UNITED STATES
DEPARTMENT OF THE INTERIOR
BUREAU OF LAND MANAGEMENT

FORM APPROVED
OMB NO. 1004-0135
Expires: July 31, 2010**SUNDRY NOTICES AND REPORTS ON WELLS**
*Do not use this form for proposals to drill or to re-enter an abandoned well. Use form 3160-3 (APD) for such proposals.***SUBMIT IN TRIPLICATE - Other instructions on reverse side.**

OXY USA WTP LIMITED PARTNERSHIP respectfully request permission to make a change to the cementing plans on the original APD. Please see the attached documentation for your review. If you have any questions or need further information, please feel free to contact us at any time.

OXY USA Inc
Piglet 21 Federal 9
Sundry Information

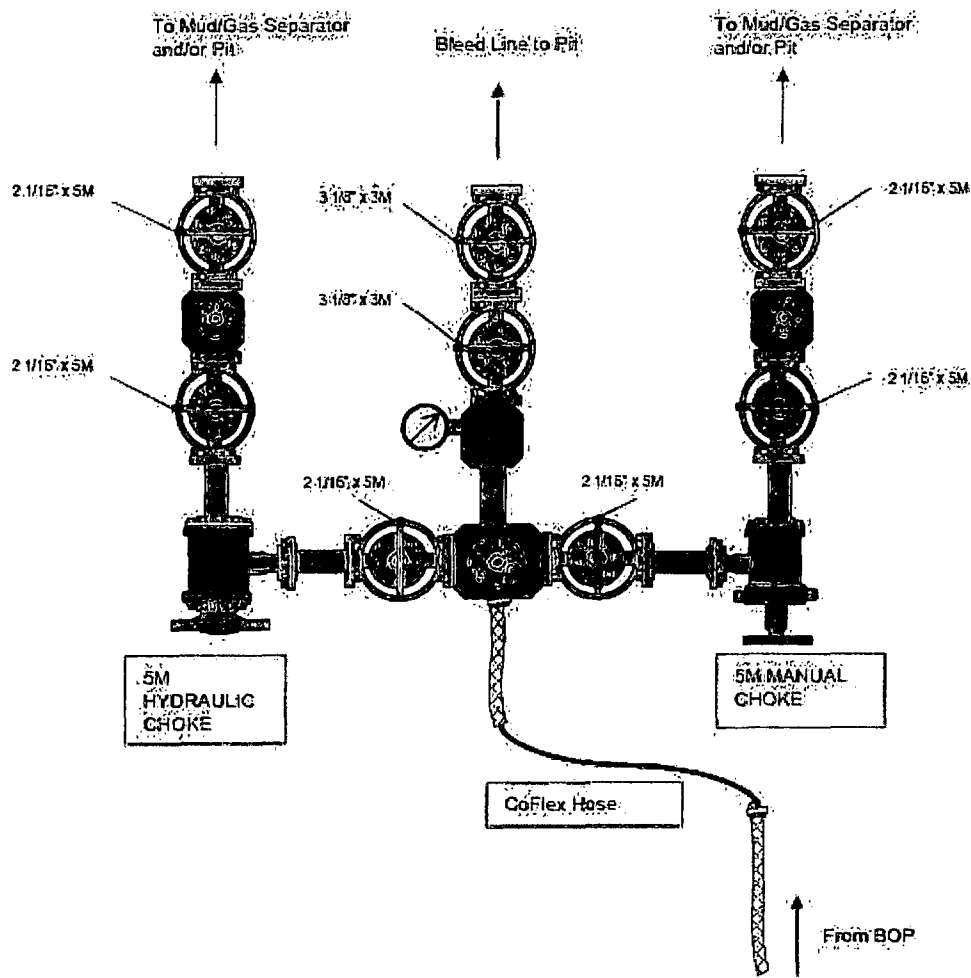
- a. Based on historic wells drilled in this area, the surface and production cement volumes have been adjusted. This will allow us to cut down on the excess cement having to be hauled off and exposed of.
- b. We will only run the 100 sks of lead thixotropic cement if losses occur while drilling the surface section.
- c. If a caliper log is run, cement volumes will be adjusted to caliper volume + 35% excess for the production hole.
- d. The corrected choke manifold and bop schematic can be found below. Oxy requests a variance to use the corrected choke manifold and bop.
